ADDENDUM NO. 1

Date: October 10, 2022
Issued by: Sacramento City Unified School District
Project: **Project #0520-442**
Hiram Johnson HS Baseball/Softball/Golf Facility

SYNTHETIC TURF - PUTTING GREEN SECTION

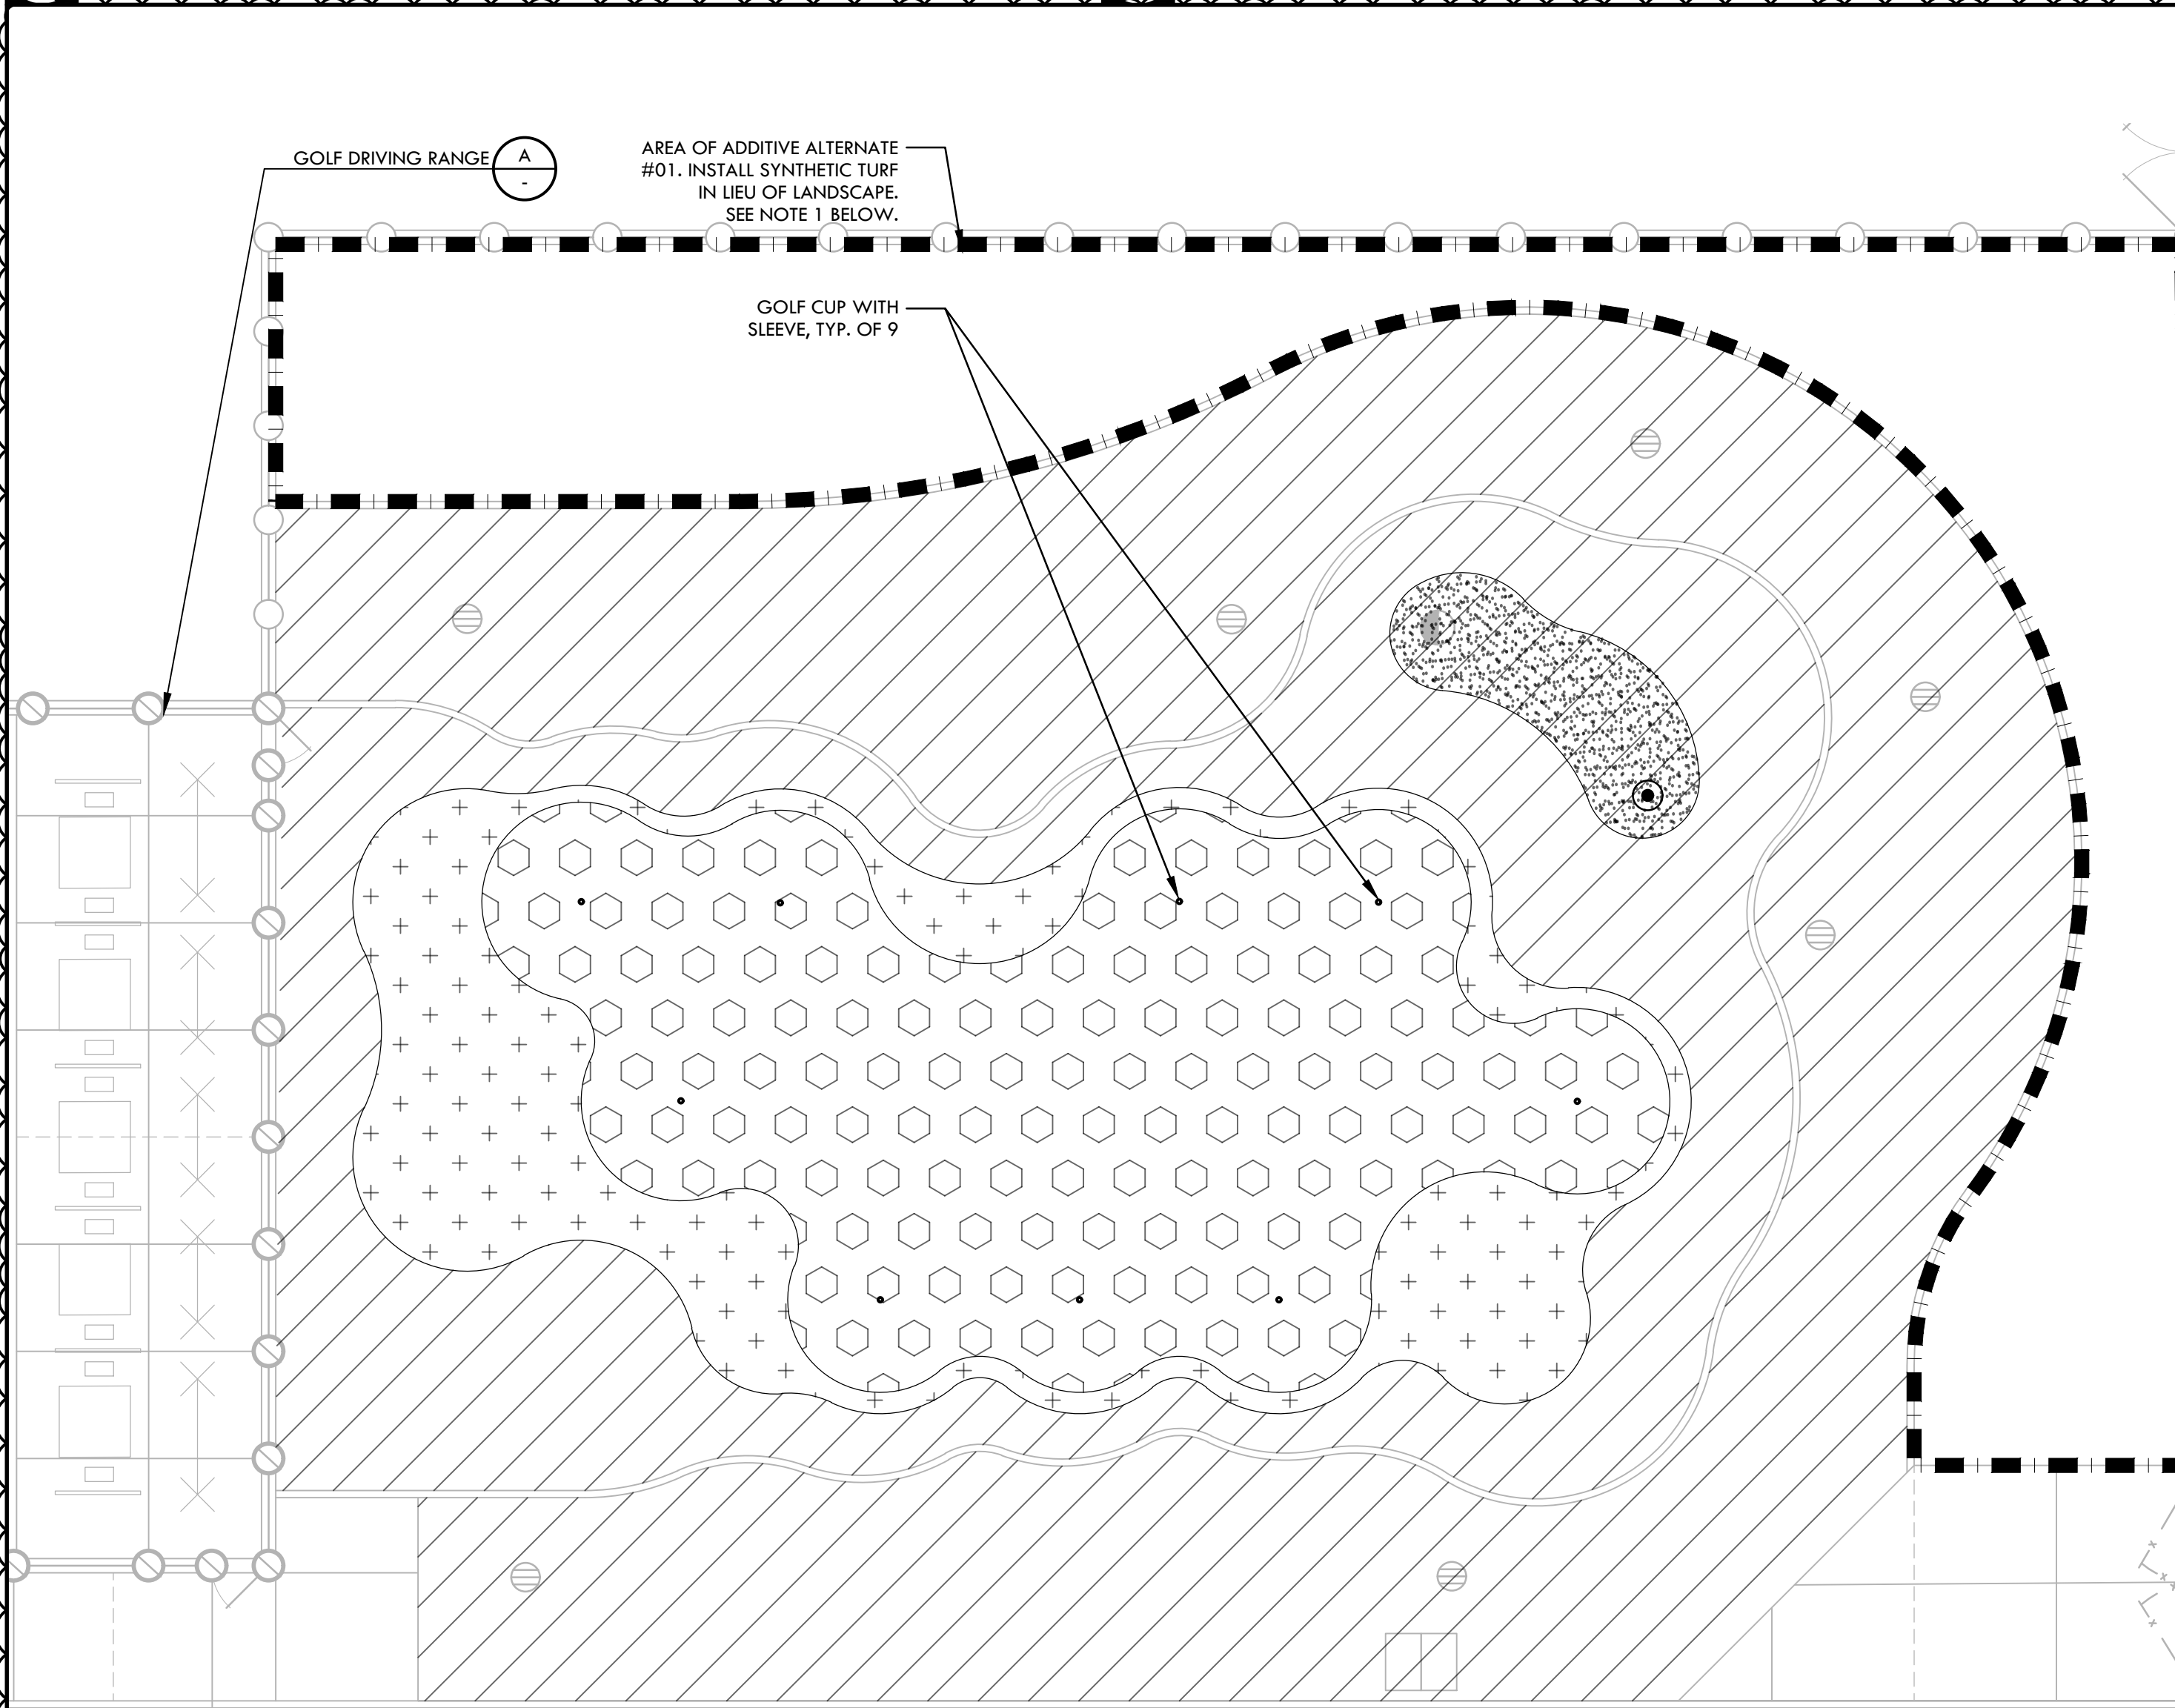
2. Please provide specs for aggregate layer with bonding agent that is under sandbunker per detail G/D5.1

A: The 4" aggregate layer with bonding should be a graded stone aggregate having an average size of between 1.8 millimeters and 50 millimeters. Bonding agent to be Sportcrete.
